# Amendment Notice 2

**Licence Number** L8240/2008/2

**Premises**  
Narembeen Wastewater Treatment Plant  
Lot 28597 on Plan 182591  
Crown Reserve 35856  
Soldiers Road  
NAREMBEEN WA 6302

**Date of Amendment** 4 July 2018

**CS03204 Narambeen Shire Reuse**

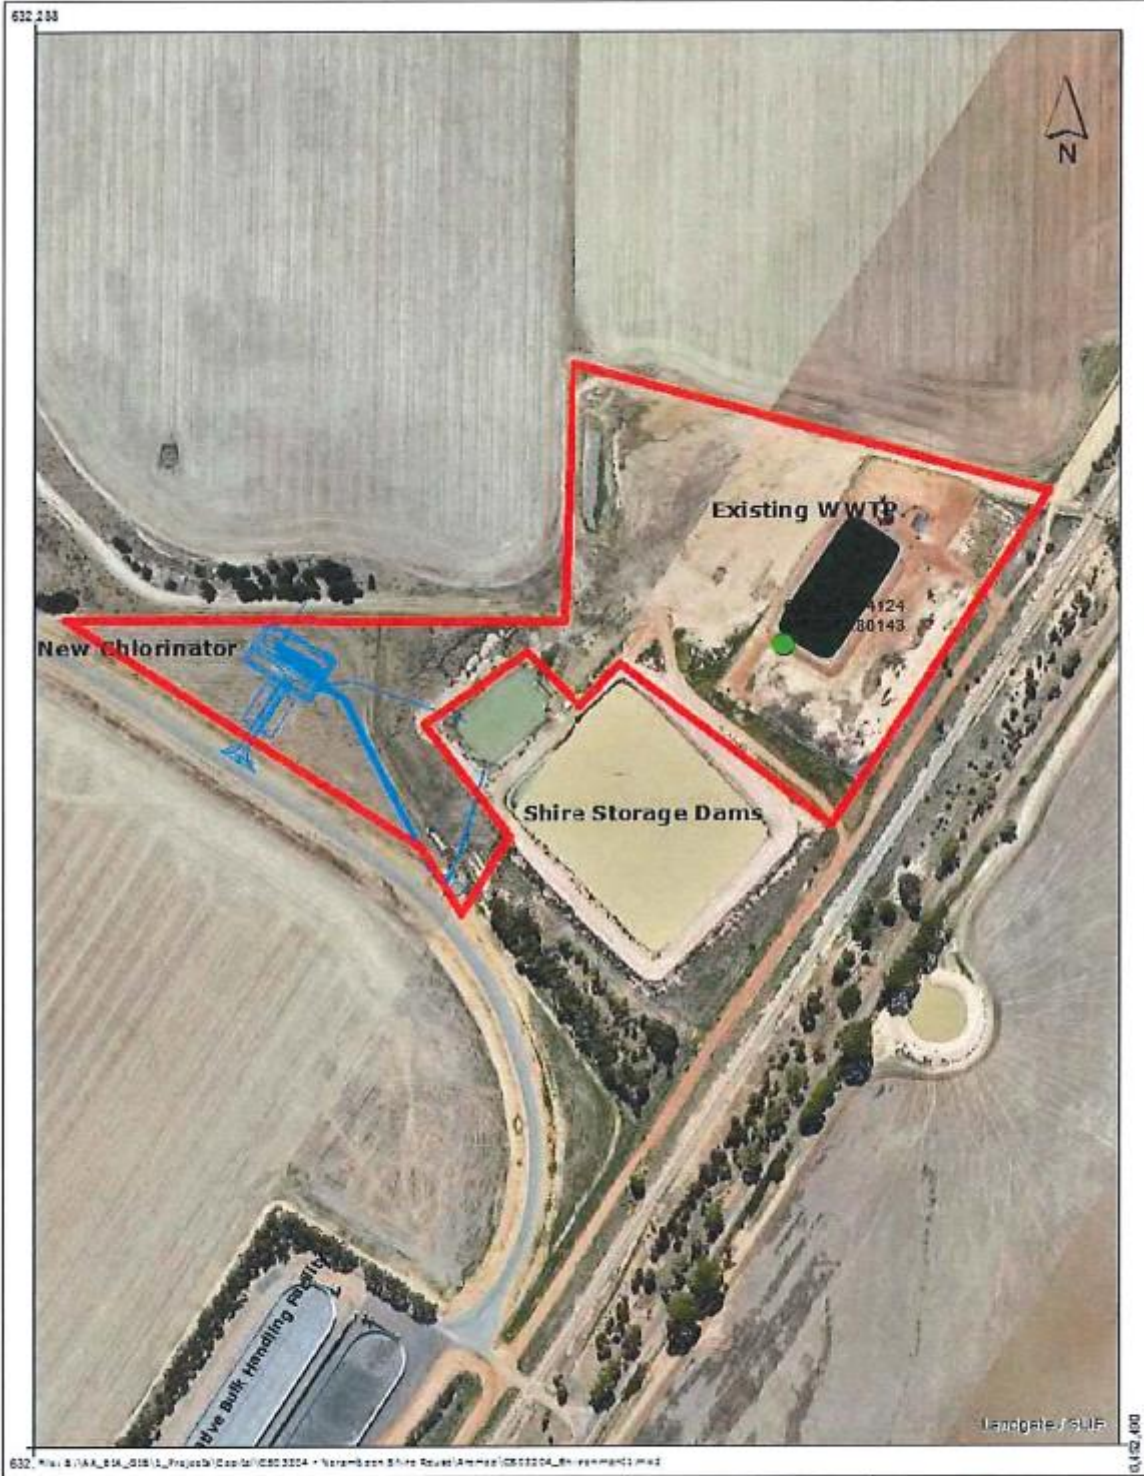
3. The Licence is amended by the insertion of the following Map in Schedule 1:

Change to infrastructure wording for the Mechanical Filtration System to remove requirement that the system is able to achieve disinfection of 200microns, as this is a filter.	Proposed change accepted.
	Change to infrastructure requirement wording for the Pump Station to clarify that 5.6 litres per second is the maximum flow rate.	Proposed change accepted.
	Change to infrastructure requirement wording for the New Effluent Pipeline to remove the length and width requirements.	Proposed change accepted.
Premises map	Updated premises map provided – relocation of discharge point.	Proposed change accepted.
